**Re: Comments on Ongoing Work to Satisfy the Red Hill Bulk Fuel Storage Facility
("Facility") Administrative Order on Consent ("AOC") Statement of Work
requirements 7.1.3 (Groundwater Flow Model Report) and 7.2.3 (Contaminant Fate
and Transport Report).**

Subject: Comments on the State of the Conceptual Site Model and Related Evaluations for the Navy
 Red Hill Tank Farm Facility, Pearl City, Hawai'i

Subject: Comments on Presentation Materials from the Red Hill Groundwater Modeling Working Group (GWMWG) Meeting #7 and Status of Interim Modeling as Presented Associated with Administrative Order on Consent ("AOC") Statement of Work Requirements 7.1.3 (Groundwater Flow Model Report) and 7.2.3 (Contaminant Fate and Transport Report)

RE: **Comments on the Progress of the Red Hill Groundwater Flow Model**

Figure 1. A comparison of the simulated and measured groundwater elevations in the RHMNW. RHMW07 is excluded from this graph since the water level in this well is very anomalous. The Red Hill Shaft (2254-01) is also excluded due to questions about the top of casing reference

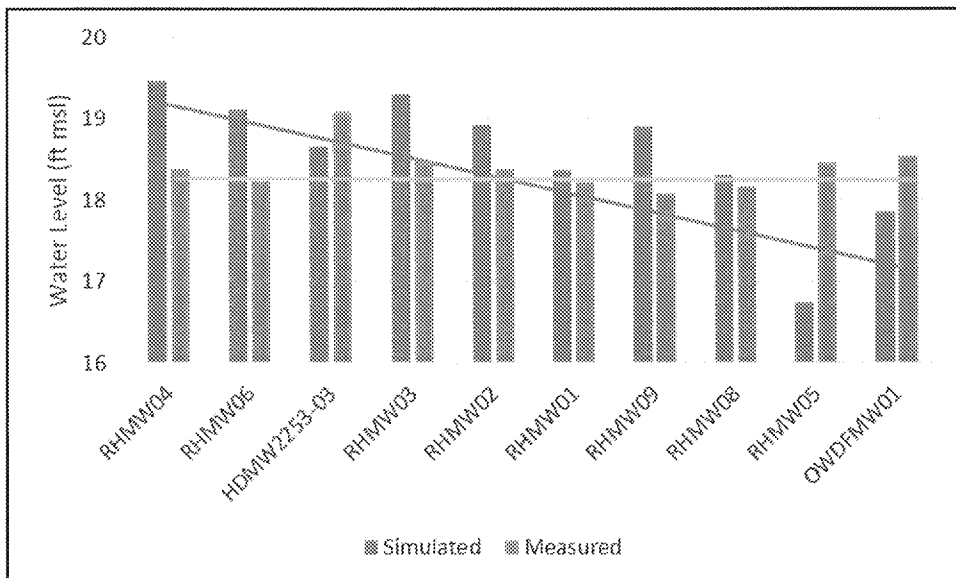
The model results presented in the February 12th Red Hill Groundwater Modeling Working Group (RHGWMWG) meeting show groundwater elevation patterns much different from those measured. For example Slide 24 from the February 12 RHGWMWG meetings shows that the simulated water level near RHMW05 is about a foot lower than that at RHMW02, much different than what is measured. In fact this infers a gradient of more than 3 feet per mile, rather than the flat gradient that is consistently measured. More importantly, for the Red Hill Shaft zone of contribution shown in Slide 57 to be valid the relative groundwater elevations simulated by the model within that zone of contribution should be in close agreement to those measured in the field.

The bar graph below compares the modeled groundwater elevations (blue bars) to those measured in 2017 (orange bars). The data are arranged going from RHMW04, the most upslope well, to OWDFMW01, the most down slope well. A visually estimated trend line is drawn for each data set. The values for the modeled groundwater elevations were derived by applying the modeled residuals in Slide 30 to the average of water level measurements during the July and November rounds of groundwater sampling. For the modeled capture zone shown on Slide 57 to be valid there should reasonable agreement between the trend in the modeled and measured groundwater elevations. Clearly this is not the case, and the presented model is essentially no better than that of Rotzoll and El-Kadi the Red Hill investigation is tasked to improve upon.

If the zone of contribution for the Red Hill Shaft is in error, then likely that for the Halawa Shaft is also in error. Also, the data need to be presented in such a way that reviewers can easily determine whether or not the conditions for model validity are met. The calibration graph shown in Slide 26 does not provide sufficient information to allow an assessment of model validity. It also appears that wells on the extreme greatly improve the appearance of correlation between the simulated and measured water levels but may not appropriate for this purpose.

In summary, for the groundwater flow model to be acceptable as a risk assessment tool, there must be much better agreement between the simulated and measured water levels in the critical areas. These areas are the Moanalua area wells, the RHMNW wells, and the wells in the Halawa area.
